Harwich Planning Board Meeting Agenda

PB2020-28 Cape Cod Oil

Staff Report- May 11, 2021 Public Hearing (continued from April 13, 2021)

Re: Response to Comments Letter Cape Cod Oil – Site Plan Review Application 6 Station Avenue, Harwich, MA 02645 IDE Project Number: 01-2020-015

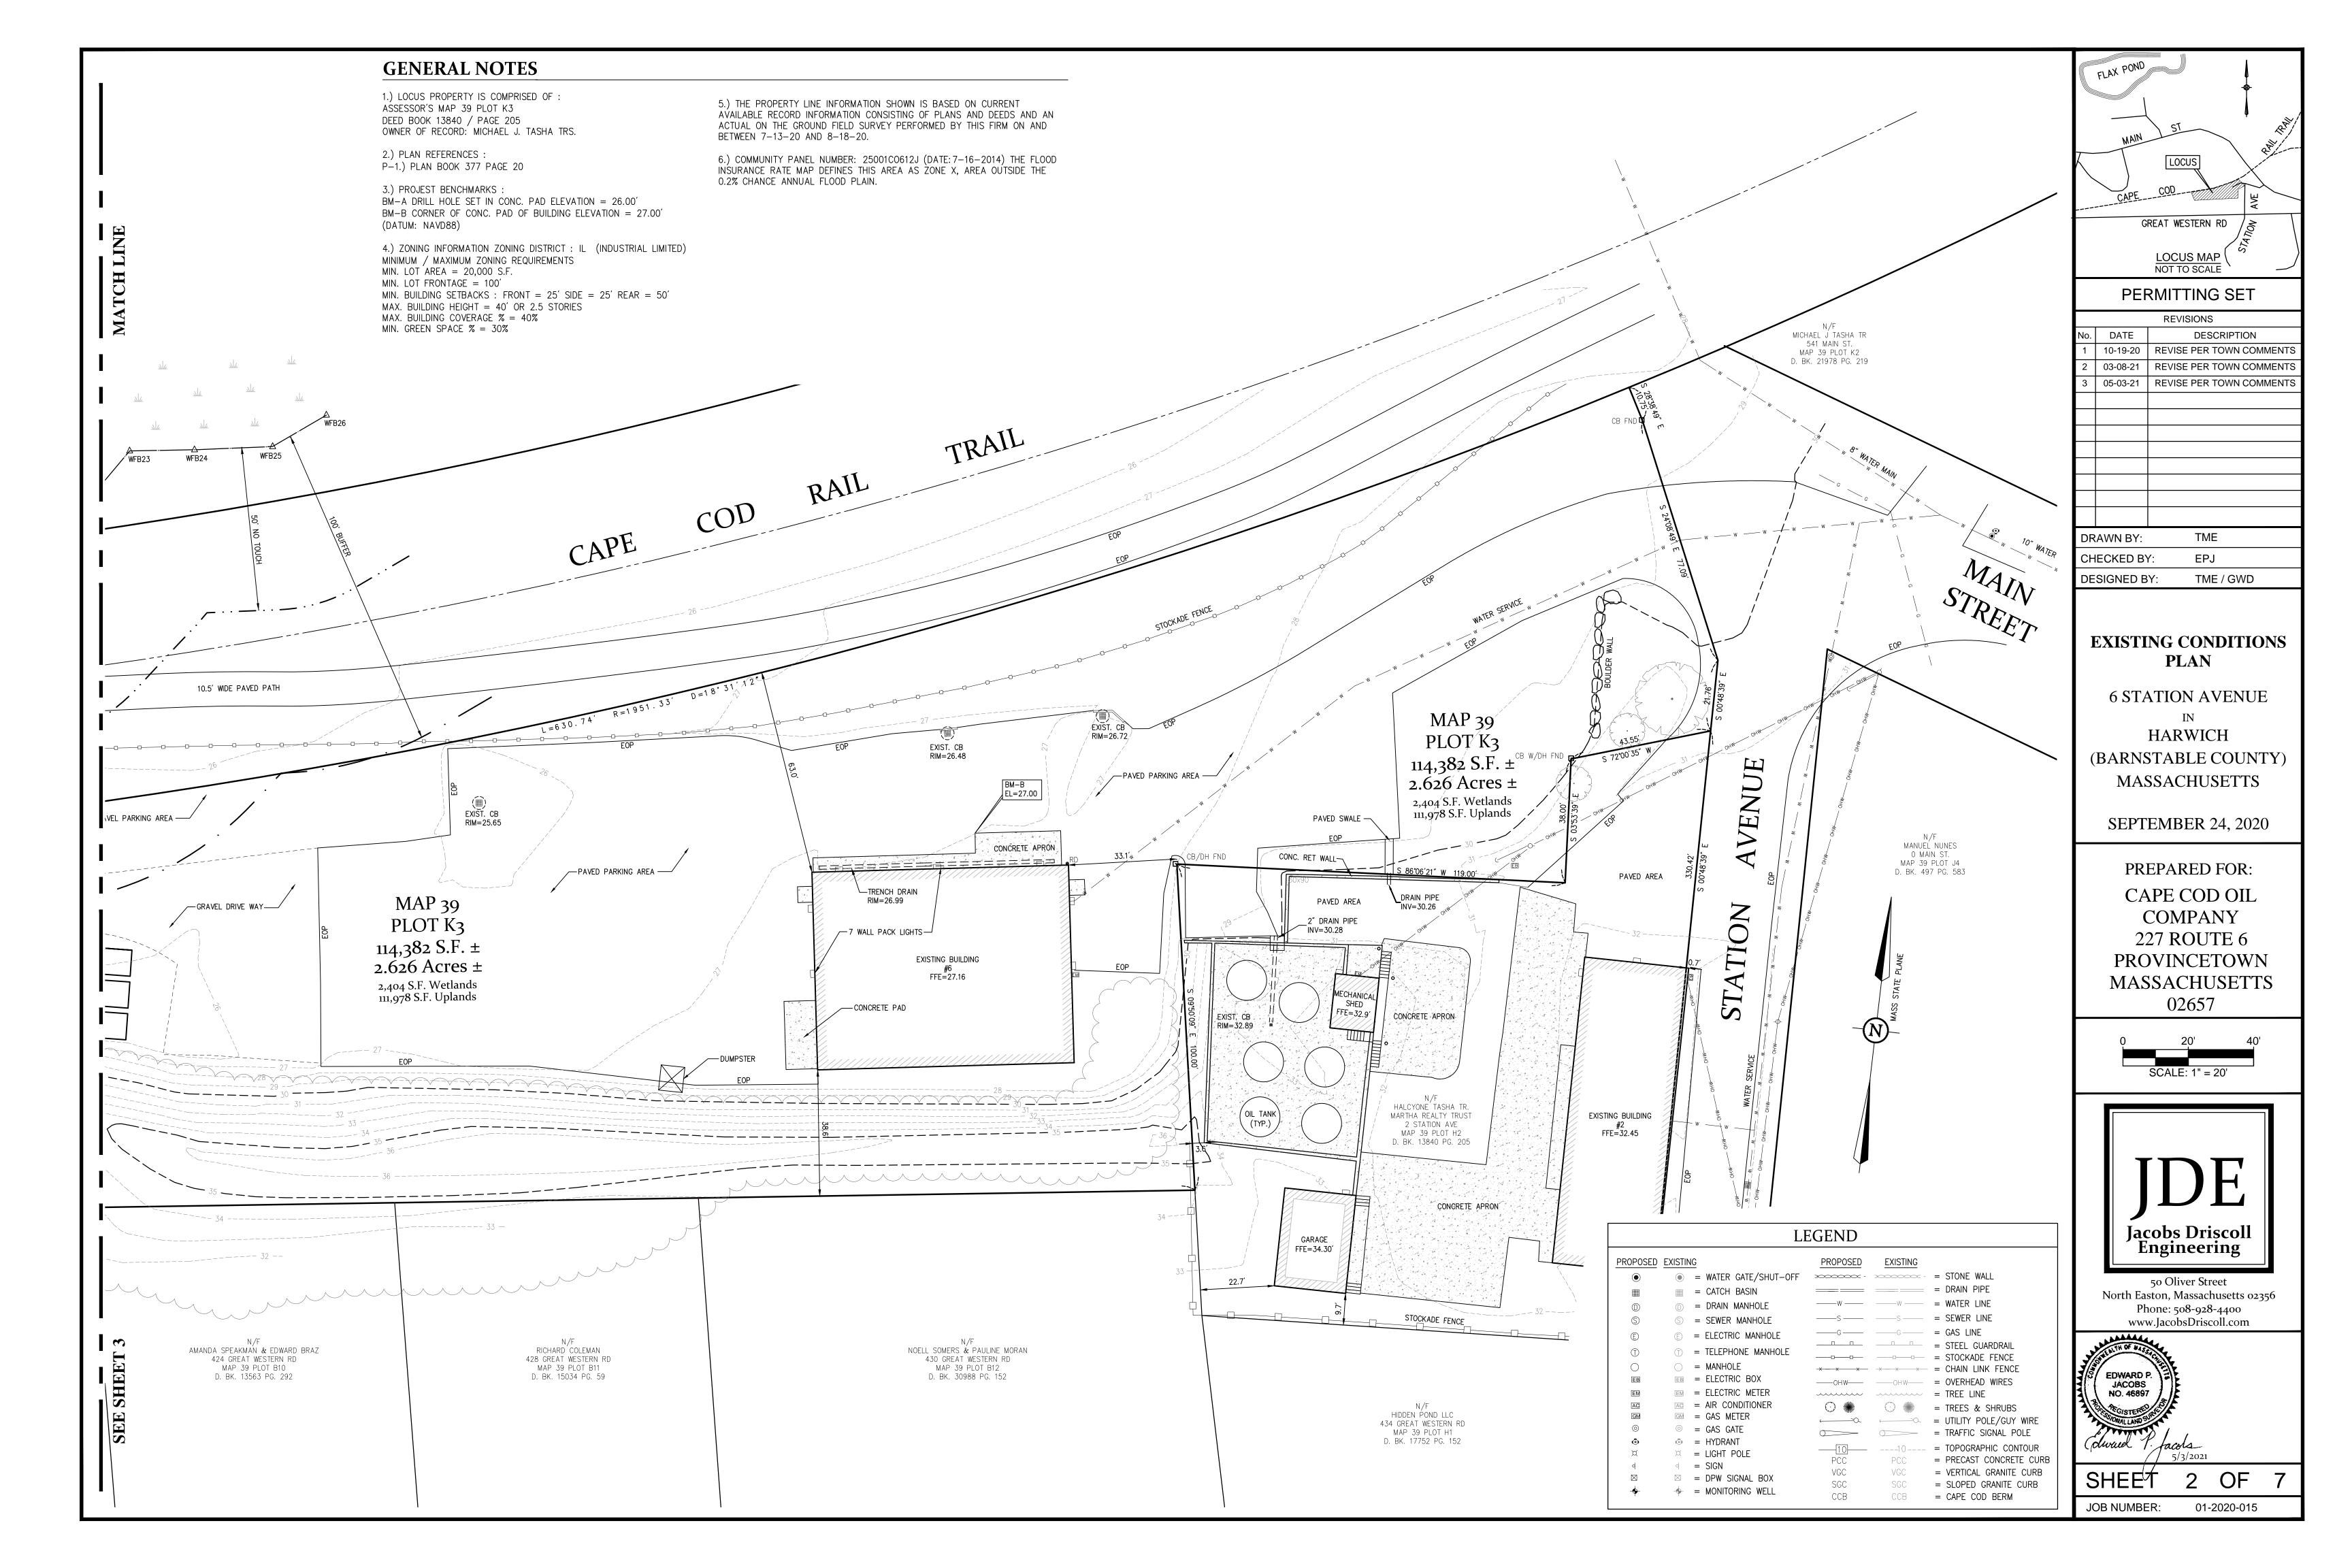
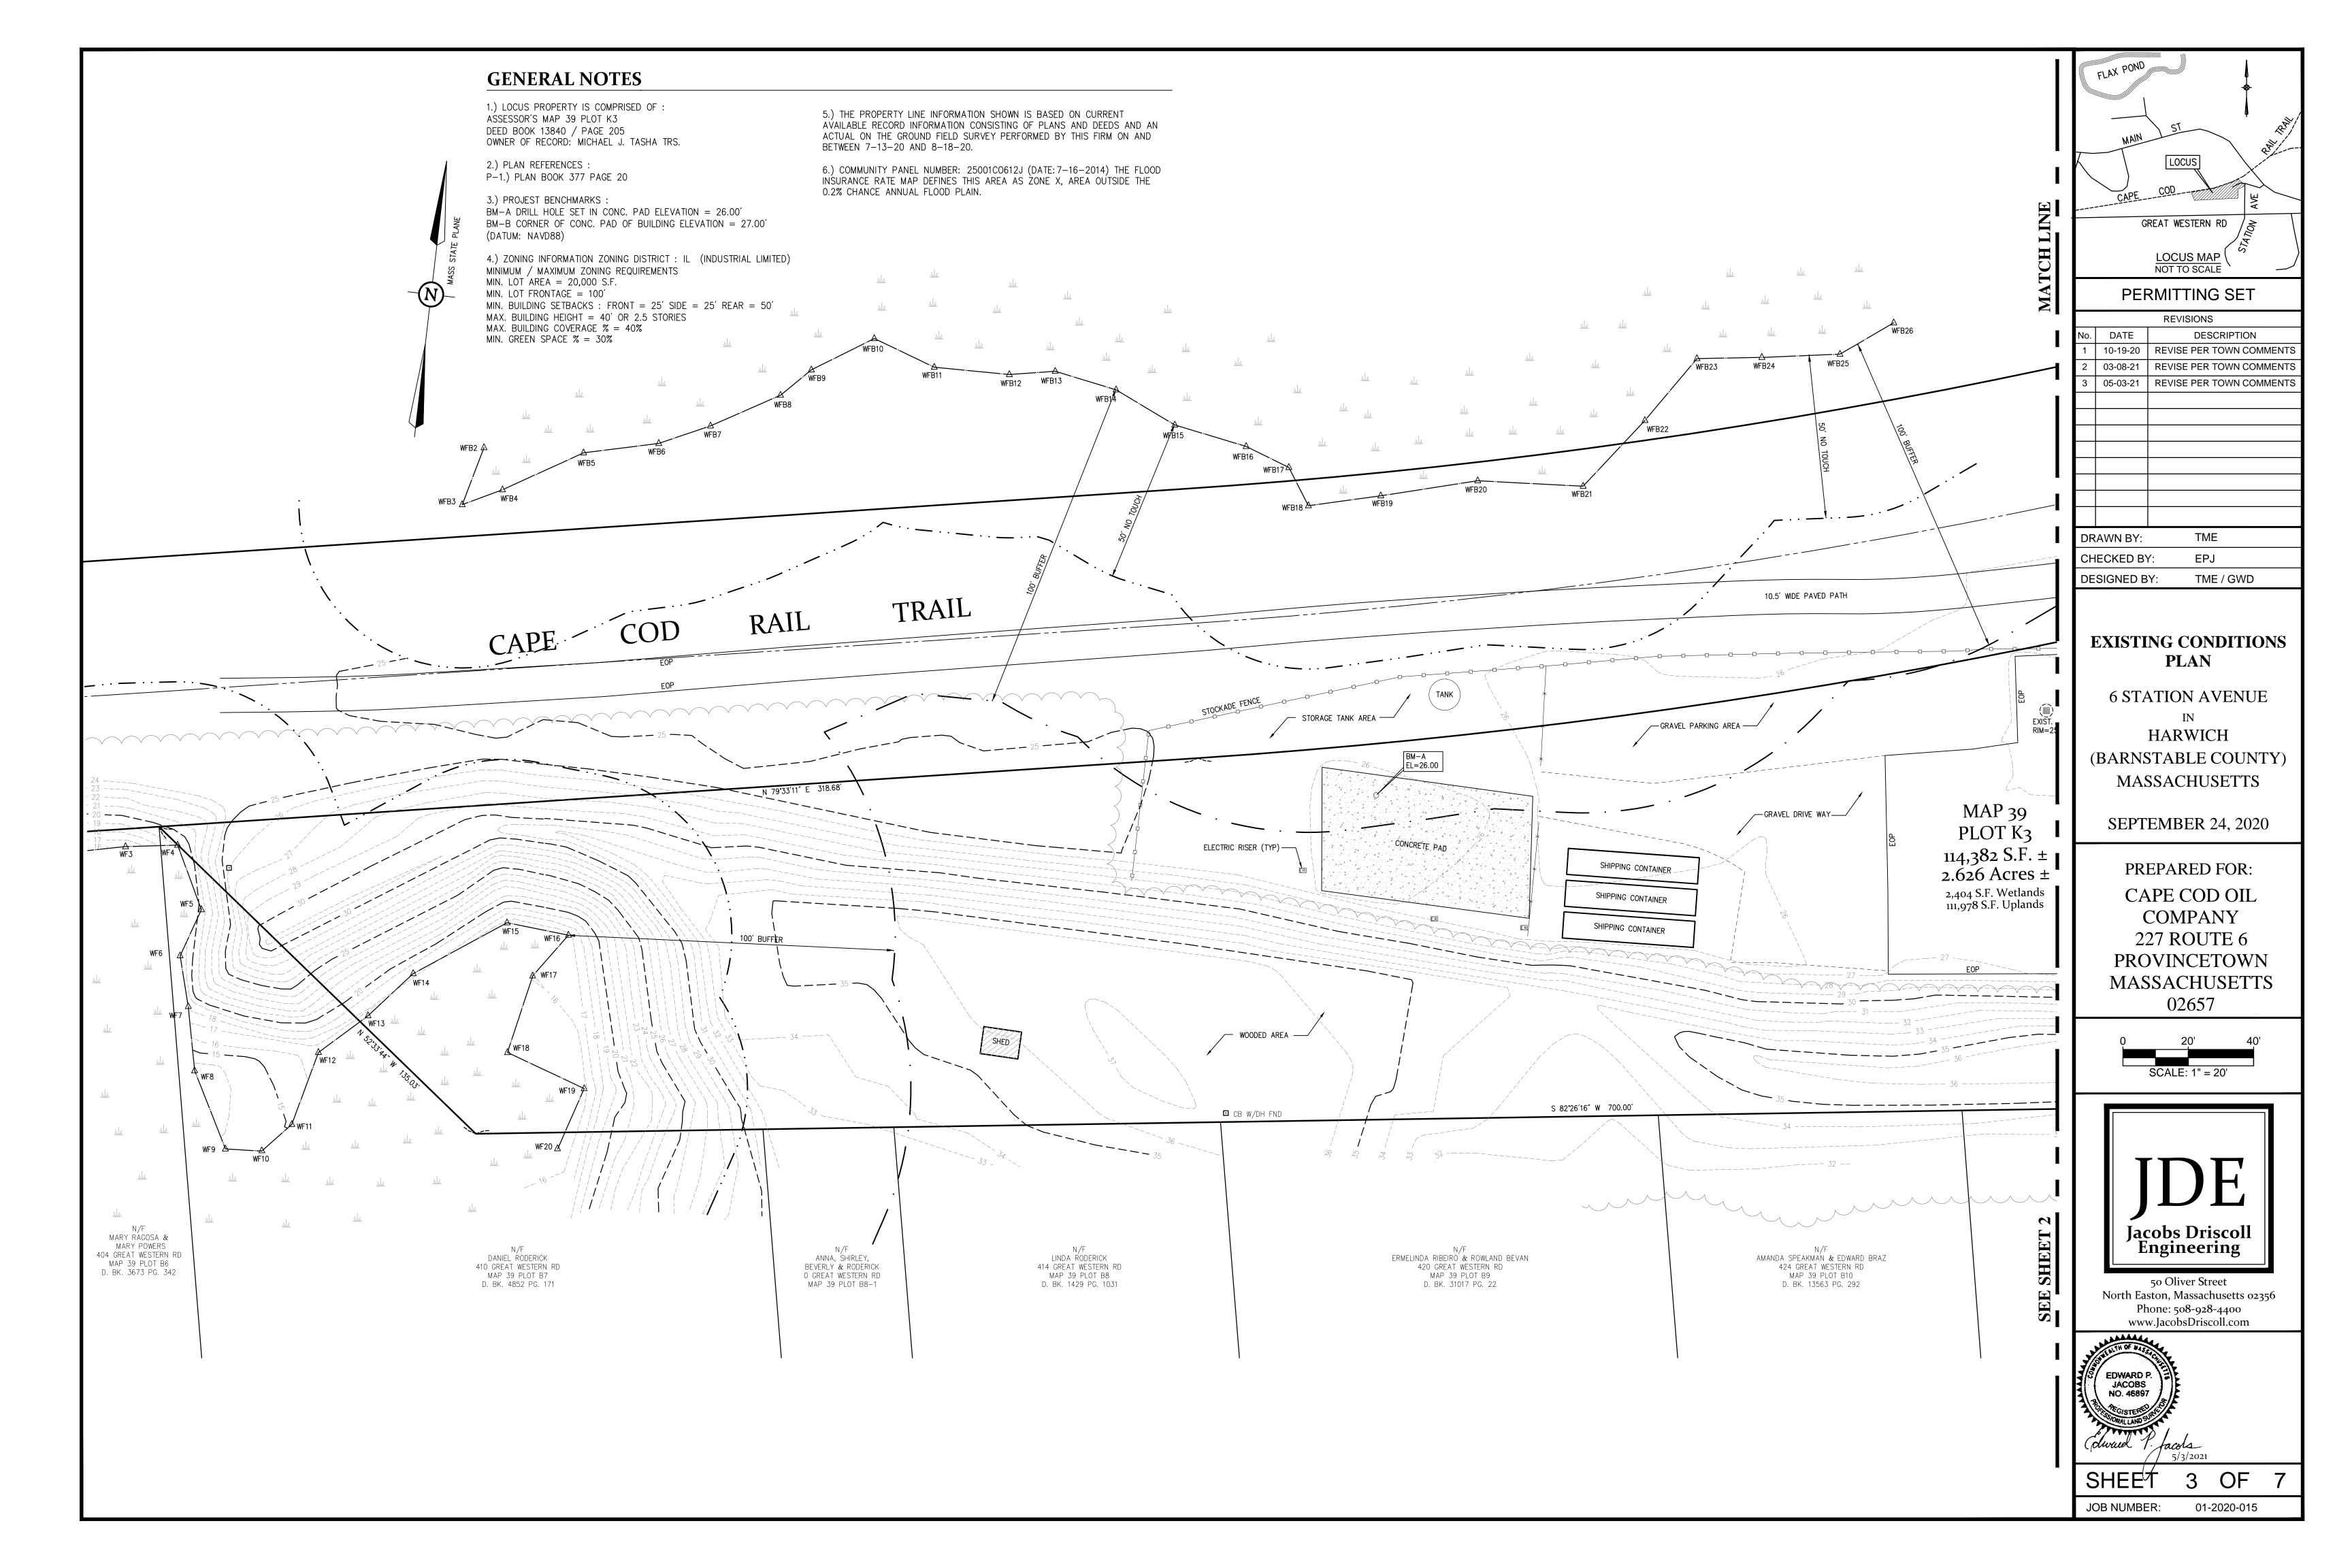
12. Comment – At this time I saw storage space for 10 trailers on site. It is currently undetermined where the other twelve may be stored or where they may be located in the future.

2. Comment – The area marked storage tank area and the stockade fencing along a portion of the north boundary line is encroaching on the Cape Cod Rail Trail. An easement must be provided for continued permission to for this use.

3. Comment – There are three shipping containers and a shed shown on the existing conditions plan. Uses for these items should be determined, particularly the containers if they are to be located. If relocated, the plan and approval shall be incorporated into the findings and decision. This may require re-examining the parking schedule.

JDE Response – As shown on Sheets 4 & 5 of the plan set, there are 22 proposed trailer spaces on this site. 6 trailer spaces are proposed along the edge of pavement to the north, 6 trailer spaces are proposed on the concrete pad on the west end of the property, and 10 trailer spaces are proposed along the boulder wall at the east end of the property.

JDE Response – The storage tank area will be relocated out of the 100' buffer zone as shown on the plan.

JDE Response – The existing shed shown on the plan will remain as the owner is not utilizing it at this time. The three existing shipping containers will be consolidated and relocated or removed as needed. Proposed locations for the containers are not known at this time. The owner will either remove/relocate to an appropriate location as needed.
